NUMBER: 24-008-01

Poor A/C Performance/Expansion Valve Noise

2001 (PL) Neon
2001 (P2) Neon (International Markets)

Fig. 1 AUTHORIZED SOFTWARE UPDATE LABEL

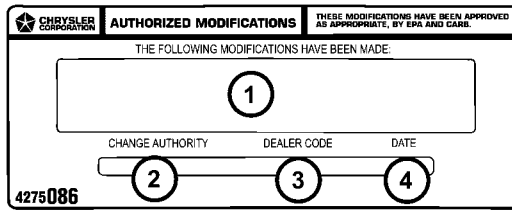
3. Type the necessary information on the “authorized Software Update Label” p/n 04669020 (Fig. 1). Attach the label to the PCM and cover the label with the clear plastic overlay. Type the necessary information on the “Authorized Modification Label” p/n 04275086 (Fig. 2) and attach the label near the VECI label.
